CITY PLANNING COMMISSION
1231 "I" STREET, SUITE 200, SACRAMENTO, CA 95814

- APPLICATION:
- A. Negative Declaration
 - B. Special Permit to develop an 8,456 square foot, 2 story church on 0.34± developed acres in the Office Building (OB) zone. (Parcel A)
 - C. Variance to locate 34 parking spaces off-site on 0.45± vacant acres in the OB zone. (Parcel B)

LOCATION: 7329 25th Street

APPLC. NO. P90-005

A-1

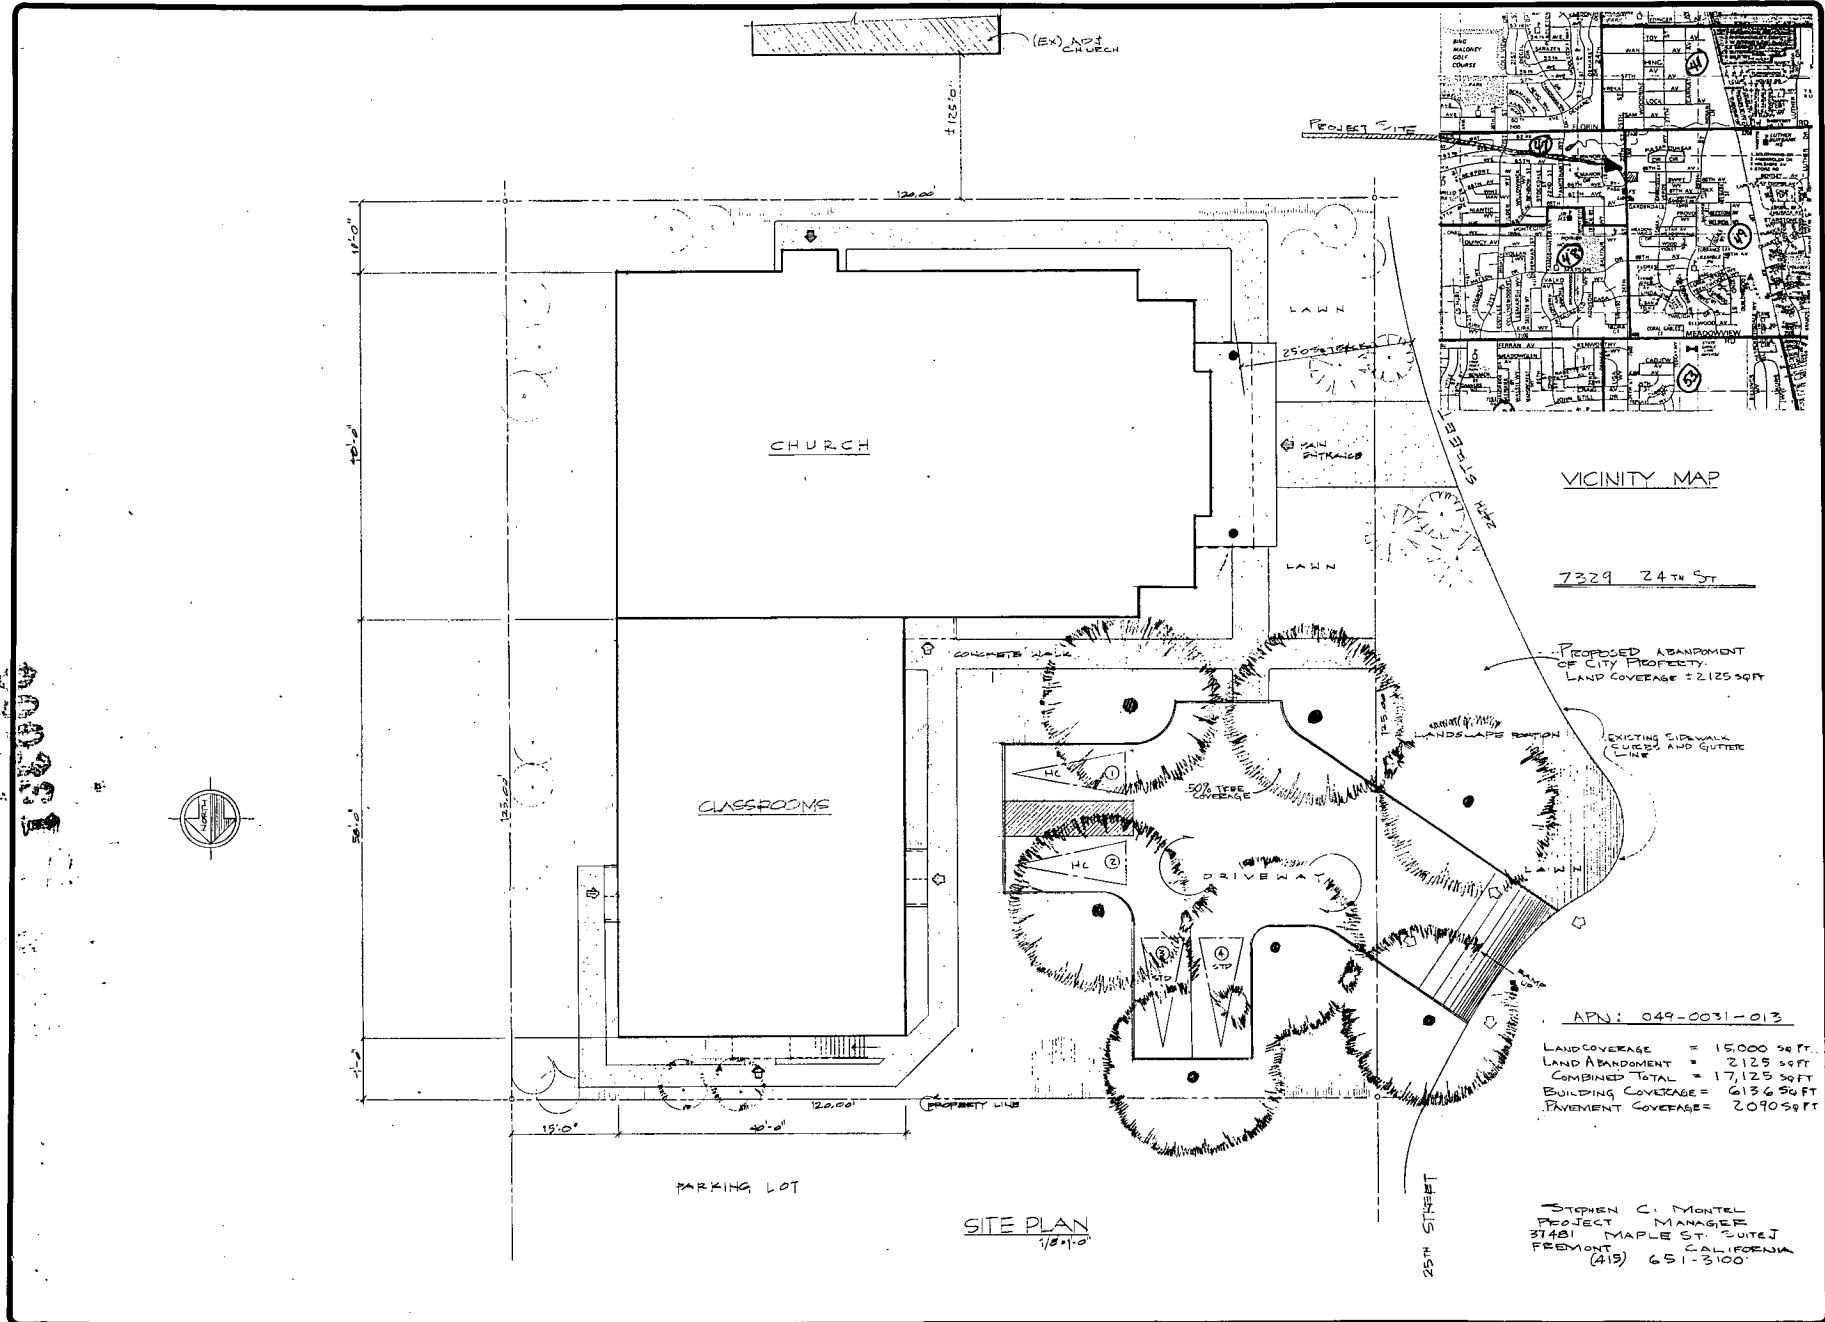
Parcel A may appear to be irregular in shape on the applicant's drawings. However, in actuality, Parcel A is rectangular in dimensions. The applicant has indicated there is a westerly property line that separates Parcel A from the bell shaped portion of land that protrudes into the public street right of way (see Exhibits A & G). This bell shaped land is owned by the City of Sacramento and in order to utilize it, the applicant would be required to have the street abandoned or obtain a revocable encroachment permit.

1. Site Plan doesn't reflect existing street improvements at intersection of 24th Street bypass realignment and 25th Street. Church parcel appears to be located entirely adjacent to 25th Street, and not to the configuration submitted on sheet A-1.

4. A new site plan should be submitted showing the following:
 - a) correct R/W
 - b) proposed area of abandonment or encroachment
 - c) parking plan to satisfaction of Traffic Engineer

- d) plan showing relationship of the two sites to each other and all adjacent roads and driveways
 - e) show existing improvements and utilities, water, sewer drain pipes, SMUD, gas, telephone.

Staff recommends the revised site plan show a 25' front yard setback from the actual western property line, and that the revised site plan be submitted for Planning Director review and approval prior to issuance of building permits. The applicant is to provide the required 50% tree shading in accordance with zoning regulations.

1. The applicant shall submit a revised site plan ~~similar to Exhibit E and~~ which shows the relationship of the two sites to each other and all adjacent roads and driveways, as well as existing improvement and utilities--water, sewer drain pipes, SMUD, gas, telephone for review and approval of the Planning Director prior to issuance of Building Permits.
 - a) *the driveway for the church site shall be relocated to the satisfaction of the Traffic Engineering Division.*
 - b) *standard street improvements (including curb, gutter, and sidewalk), shall be provided on the parking lot site and the church site to the satisfaction of the Public Works Department. In addition, and necessary street improvements as determined by the Public Works Department shall*

- c) *the revised site plan shall clearly show the relationship of the parcel on which the church is located to the city public right of way and to both 24th and 25th Streets. The revised plan shall be signed and stamped by a licensed engineer or a land surveyor. (Added by staff)*

FRONT ELEVATION WEST
SCALE 1/8" = 1'-0"

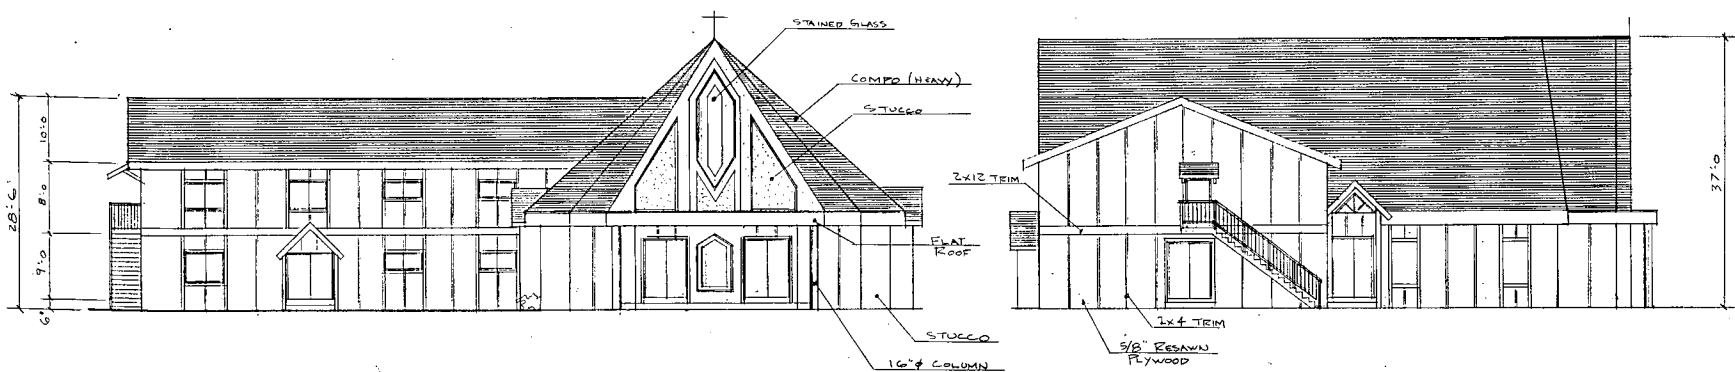
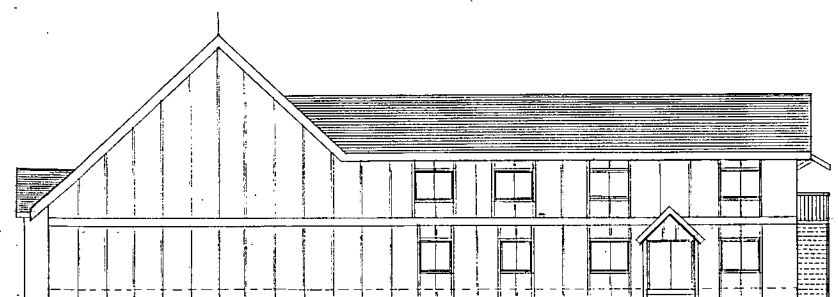
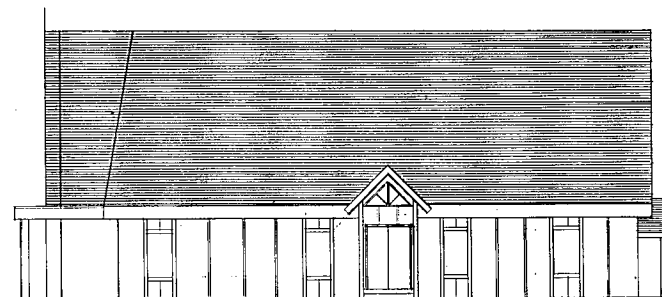
The applicant proposes building exteriors consisting of stucco and resawn plywood with composition heavy material for the roof. Staff has some concerns with the quality of the exterior materials. The following revisions are recommended:

- Replace the resawn plywood with stucco or other more suitable material
- Revise the elevations showing the new material selected and horizontal or vertical reveals
- Submit the revised elevations to Design Review staff for review and approval prior to the issuance of building permits.

The Zoning Ordinance allows a maximum height of 35 feet in the Office Building (OB) zone. The revised drawings must meet this requirement.

2. The applicant shall submit a revised elevation plan for review and approval by Design Review staff prior to the issuance of building permits.
 3. A trash enclosure shall be provided on the subject site and shall comply with the City's Trash Enclosure Ordinance.

EXHIBIT F

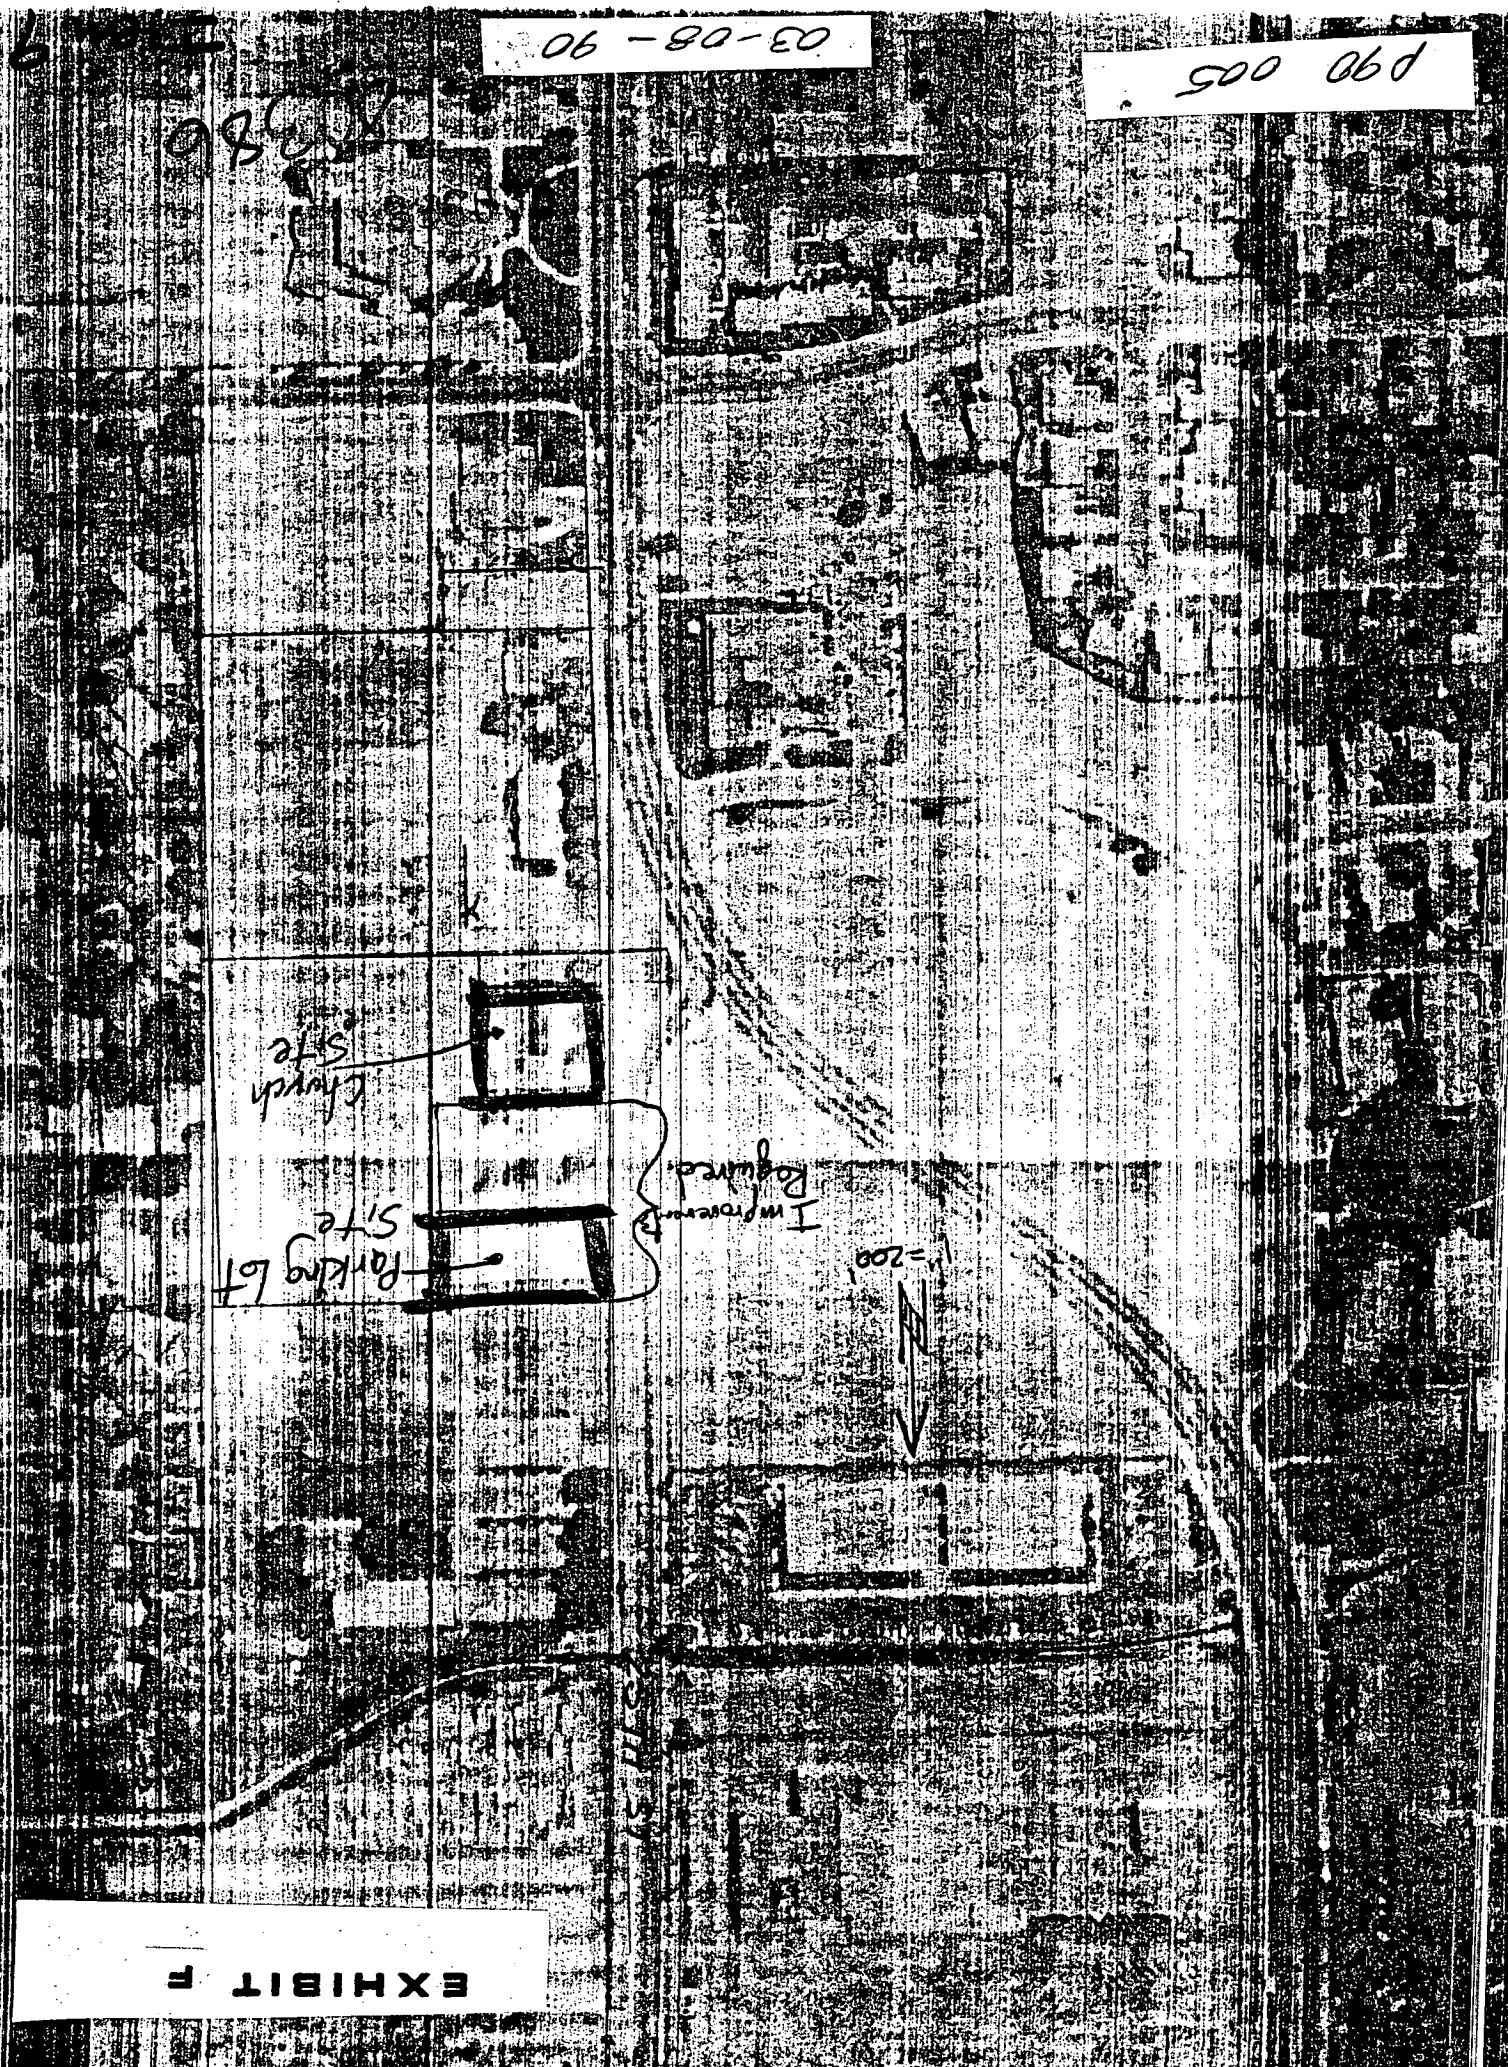
2. Frontage improvements exist adjacent to church along 25th Street. Standard improvements will be required along the parking lot and the lot between the church and parking lot. (APN: 049-0031-001, 002) The off-site improvements are required for pedestrian safety. See attached aerial photo for location of church site and 25th Street (Exhibit F).
